SUNDRY NOTICES AND REPORTS ON WELLS

MOBERLY FED. "C" #003

PROPOSED PROCEDURE FOR PLUG AND ABANDONMENT:

Permanent Abandonment of Federal Wells  
Conditions of Approval

Cimarex Energy Co. of Colorado  
Moberly Fed C #3  
1980' FNL & 660' FWL  
Sec 21 – T26S – R37E, Lea Co NM  
API # 30-025-12024  
Ground Level Elevation: 2974'

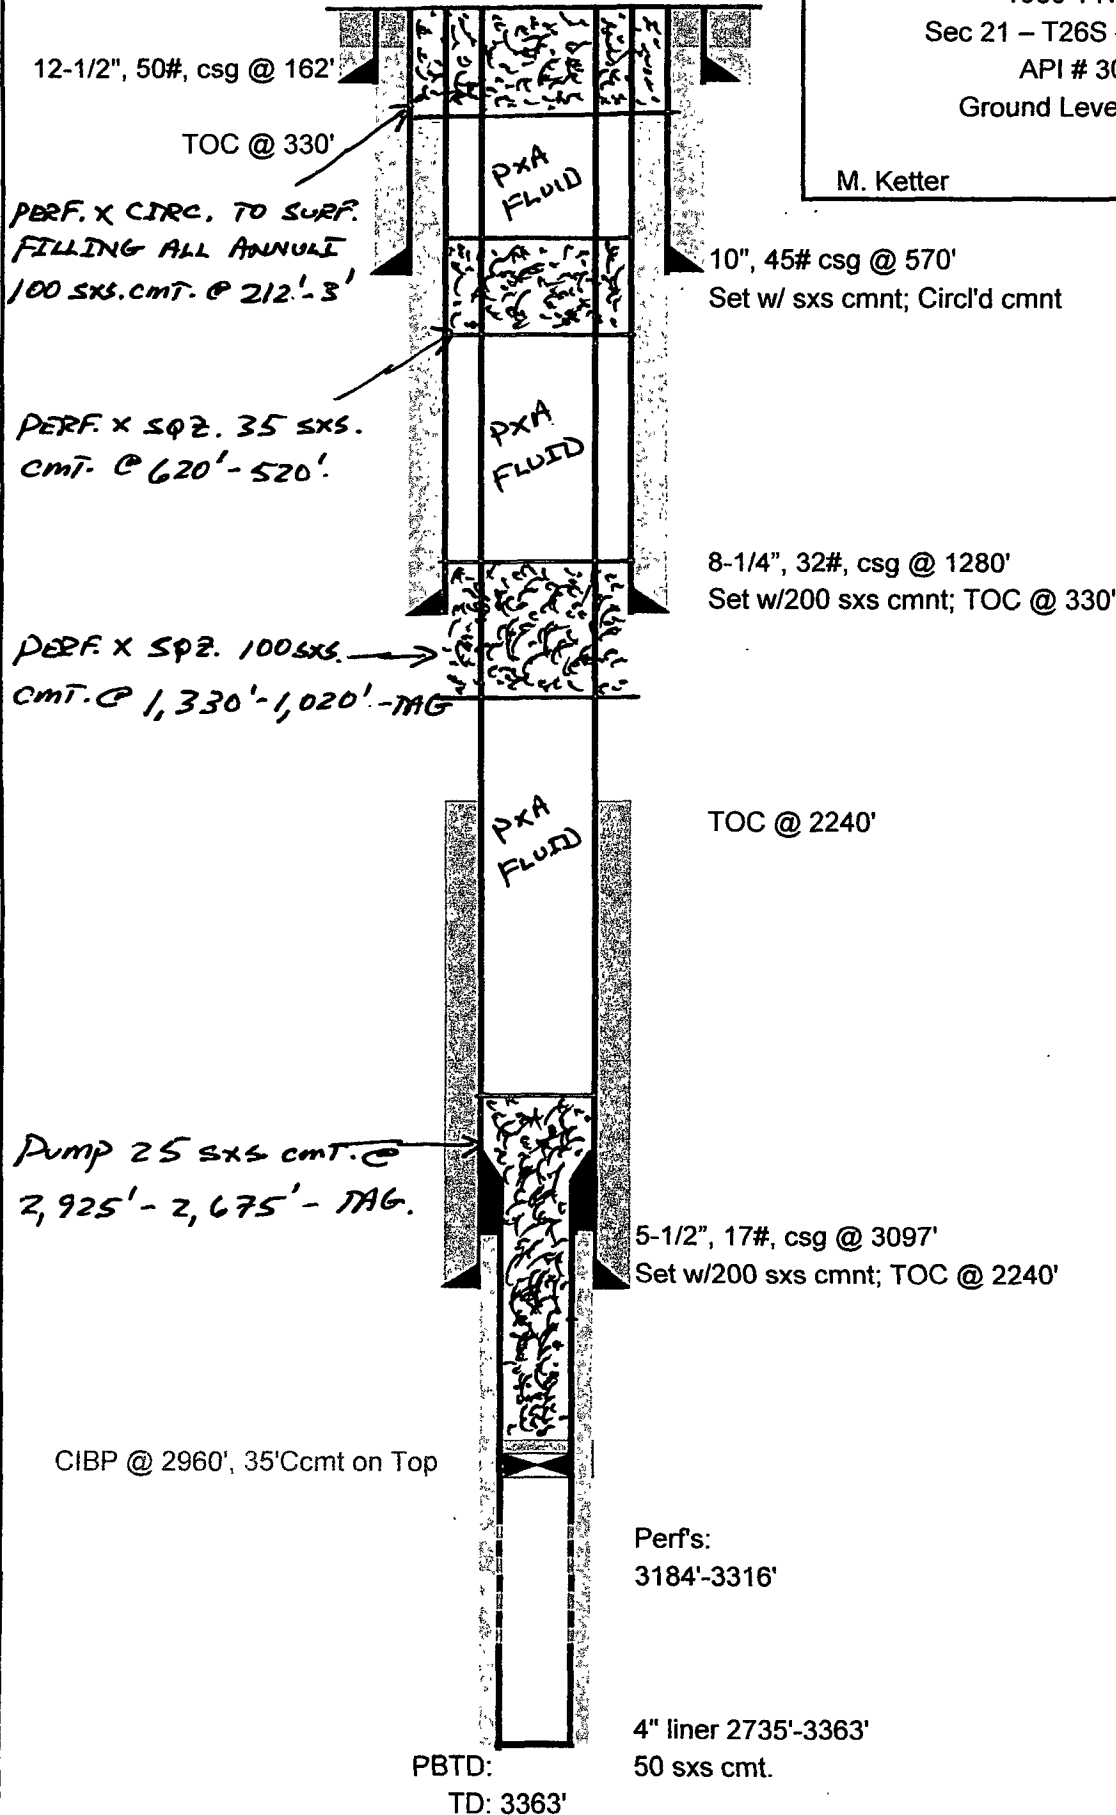
Note: Records indicate 12 1/2" and 10" casing pulled after 5 1/2" casing set. At cut-off verify cut to surface all annulus.
